## City of Ryde Submission

**DATA CENTRE - SSD-24299707  
17-23 Talavera Road, Macquarie Park**

**Alterations and additions to an existing data centre including relocation  
of drainage easement & pipes and tree removal**

**Submission Date: 21 January 2022**

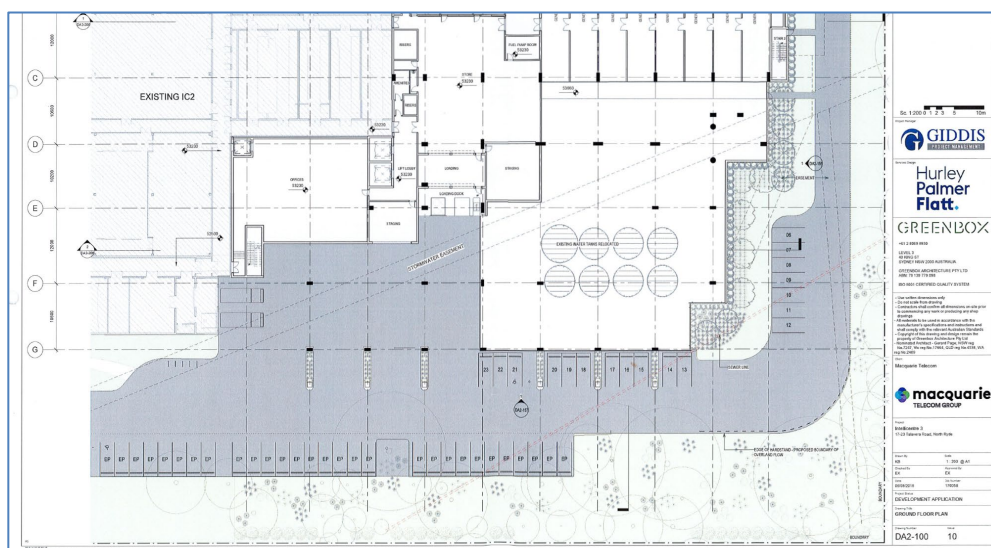
In its response to SEARs request, Council had raised an issue regarding construction of private development over a public easement. It should be noted that City of Ryde has not granted its consent as the beneficiary of the easement for applicant to build over it, with respect to this SSD proposal. Council's rights and interests under the terms of the easement are not affected by the provisions of clause 1.9A(1) of the Ryde Local Environmental Plan 2014 by virtue of clauses 1.9A (2)(a) and (3) of that Instrument.

Source: LDA2018/322

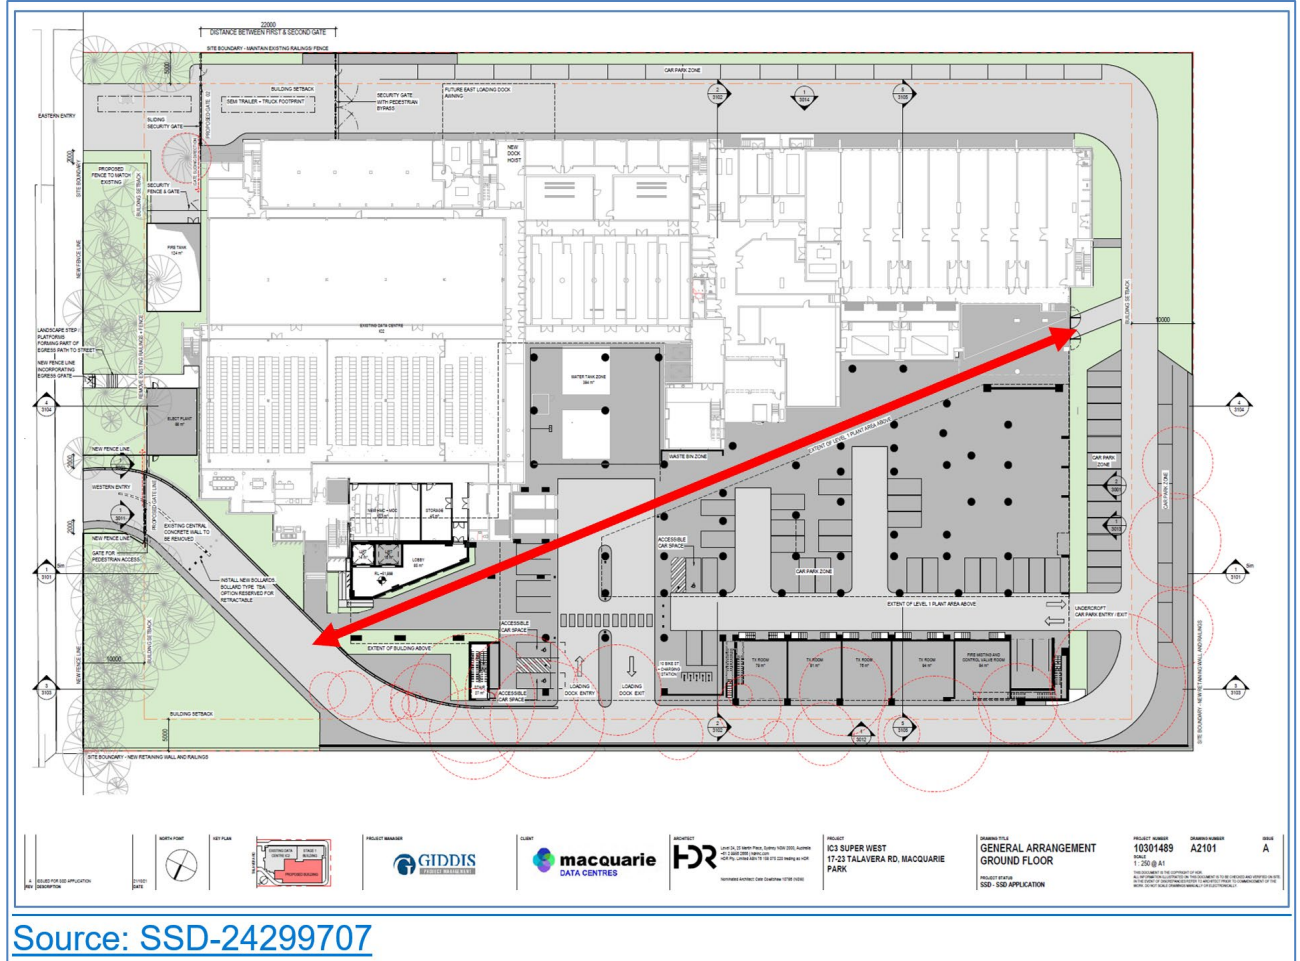
The agreement gives Council 20 years to relocate the pipe. The existing easement is to remain in place until the pipe is relocated into the new easement that has been registered on the Title. The design approved under LDA2018/322 allows for adequate clearances in terms of height and width over the existing easement in case Council is required to complete any work within the existing easement. Refer to extract of plan below showing comparatively smaller footprint over the existing easement.

The current SSD comprises of a more extensive development and seeks to build on the existing easement as well as the location of the new easement agreed in LDA2018/322. The building footprint over the existing pipe is much greater compared to previous approval and parts of the building encumbering over the easement that will limit access for maintenance and replacement will be much greater.

**SSD easement realignment Options (Source: Northrop)**

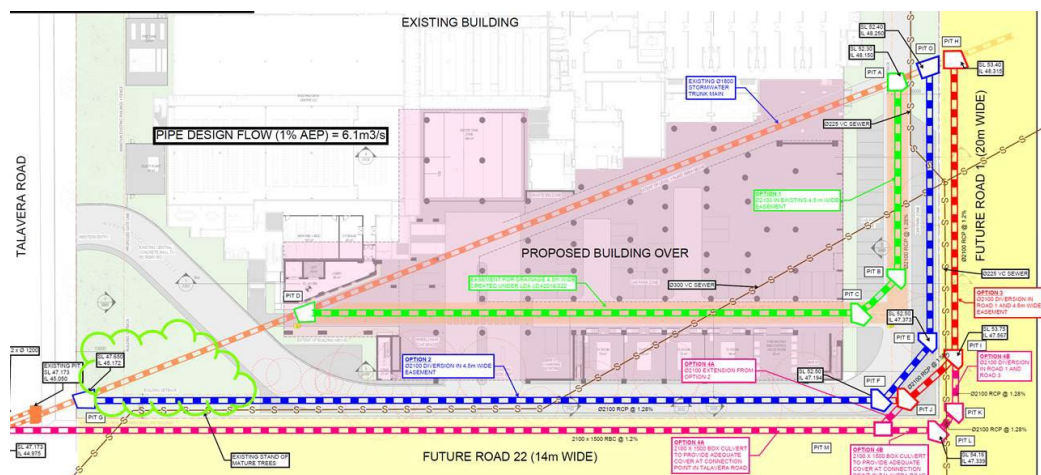
- c. Options 3, 4A & 4B (shown in red colour) are not considered feasible as they are located outside the subject property for which neither Council nor the applicant has control over at this stage. The SSD Consent cannot incorporate development on land that is not part of the subject development site. It should also be noted that future Road 22 as shown on the above plan is not in the correct location. Future Road 22 has already been approved by Council in a different location.
- d. Assuming Option 2 (shown with a blue line) is preferred by the applicant, the option has various issues for which the option is not feasible and not supported by Council for the following reasons:

- ii. The applicant is seeking to relocate the existing easement further to the north western side boundary (blue line), an alignment that is about twice as long as the existing pipes in the existing easement. The diverted easement will incur additional construction cost due to the appreciable difference between the present easement and proposed diversion, owing to the longer line and additional junction pits. This will also incur an increased maintenance cost. Council, at the very least, should not have to bear this cost.

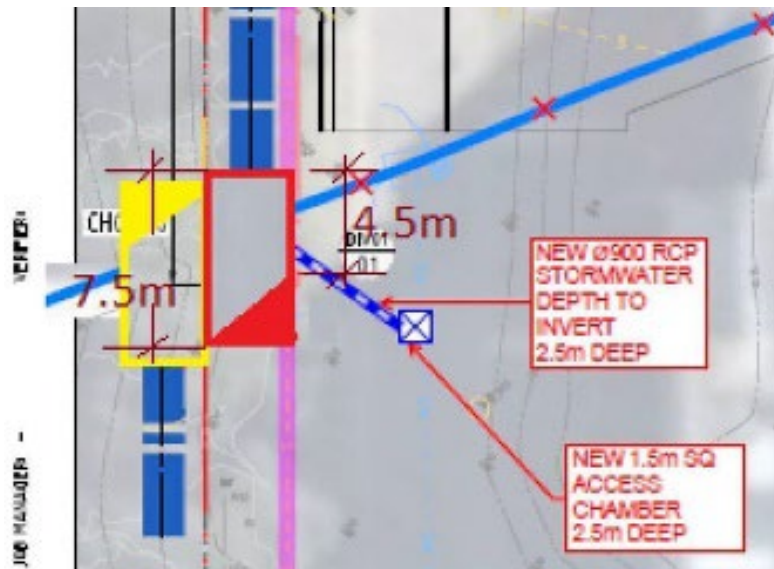
2. **Upstream Boundary Pit** to be extended and shaped to avoid turbulences internally;
    - Boundary pit at Talavera. Details of this pit to be included, paying special attention to the cover of the pipe at this

point. Pit to be extended as per the diagram below (in red the pit required at 17-23 Talavera Road site, in orange the future pit outside the boundary). Pit to be shaped to avoid turbulences internally (e.g. red triangle).
